MUTCD UPDATE & COMMENT SUBMITTALS

Prepared for PCC, NPA & IPMI May 2021 BY Mary S Smith
Copyright Walker Consultants 2021. All Rights Reserved.

This document discusses the proposed changes relative to parking, and suggests comments to be submitted by the parking industry groups and/or parking professionals. We do have a voice and can influence the standards.

Figure 2B-24. Parking and Standing Signs and Plaques (R7 Series) (Sheet 1 of 2)

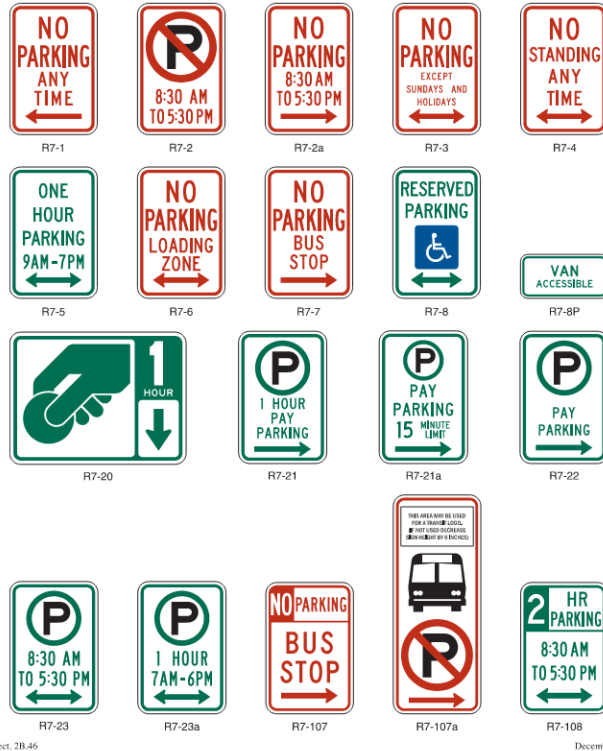
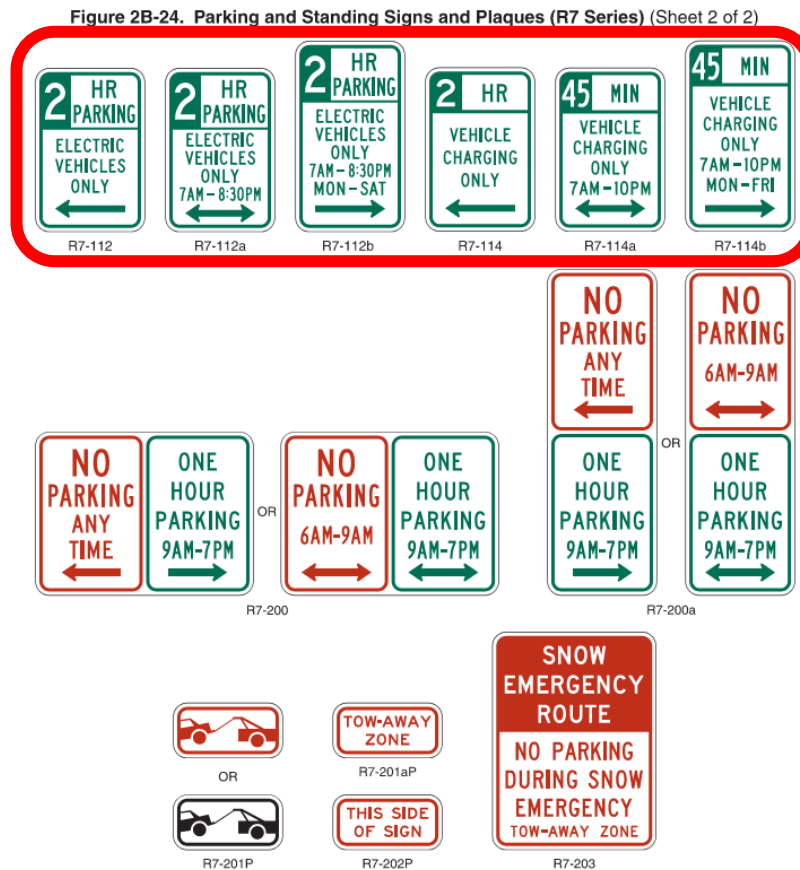
New signs highlighted in red. FHWA chose to eliminate signs showing time limits with the P in a green circle and the words Pay Parking. Note R7-21, 21a 22, 23 and 23a in 2009 and the revised versions in the NPA, especially the change to the term “metered parking”. As industry is moving away from meters to pay by phone and other means, it is strongly recommended not to use Metered Parking. NCUTCD is reportedly also recommending use of “Pay Parking”, not “Metered Parking.”

- New back in and one-hour parking signs.
- Two new EV Charging placards in black.
 - Why black? Should be green for consistency with accessible parking and new EV charging signs on sheet 2 of 2.

- Sheet 1 of 2:
 - New R7-113aP and R7-113bP: Recommend that these be put with the remaining R7-113 series signs on sheet 2 of 2, and that the color be green not black, for consistency with other parking regulation signs, such as the R7-8 accessible parking sign.

- R7-21 and R7-22: As the industry that actually administers on-street parking, we strongly recommend keeping the term Pay Parking that was used on the 2009 R7-21 and 22 signs, rather than “metered parking”. The industry is moving away from meters and agencies are eliminating meters altogether and going to 100% pay by phone. The placard R7-21 P is needed, but is not adequate as the only sign, if there is no meter. We understand the NCUTCD is also recommending use of Pay Parking rather than “Metered.”

Please comment. See suggested wording in the next section, and also discussion of Blue P for parking.

Image from US Access Board
Technical Guide: Parking, available at
<https://www.access-board.gov/files/ada/guides/parking.pdf>

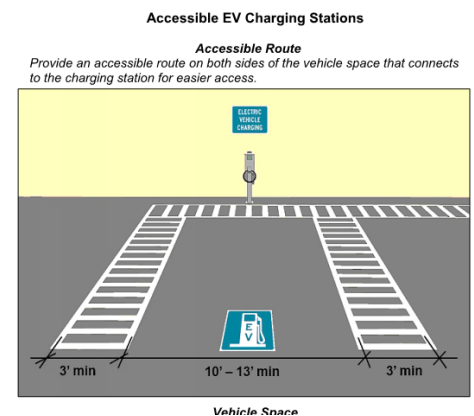
- As the 2020 NPA does not adopt the symbol, and instead uses words, on the R7-112 & R7-114 series signs, it seems that FHWA still does not believe the symbol is appropriate for parking regulation. Note that if a symbol is not shown on that series sign in MUTCD, it can't be used.
- In 2021, we strongly disagree that D9-11b does not effectively convey the use of the stall.
 - If it is recognizable and acceptable on Service Signs and Plaques, and has been in use for over a decade, then it is appropriate for parking regulation.
 - In 2014, the Access Board issued guidance recommending use of the same symbol for EV Charging Stalls.

Please comment and if possible, support using the EV symbol on parking regulation signs.
